TRANS/WP.29/GRE/2001/31/Rev.1
17 July 2002

World Forum for Harmonisation of Vehicle Regulations (WP.29)

PROPOSAL FOR DRAFT AMENDMENTS TO REGULATION No. 48

(Installation of lighting and light-signalling devices)

EXAMPLES OF LIGHT SOURCE OPTIONS

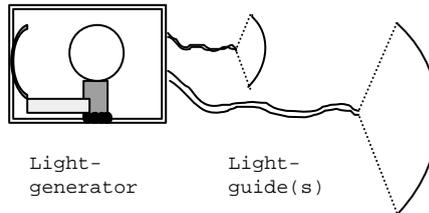
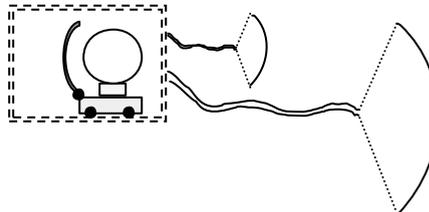
Insert a new annex 10, to read:

'Standard'

Light Source:
Replaceable
Approved to Regulations

LIGHT SOURCE MODULE
Light Source:
Non-replaceable
Non-approved

SEALED
Light Source:
Non-replaceable
Non-approved

DLS

Light-
generator

Light-
guide(s)

Outer
lens(es)
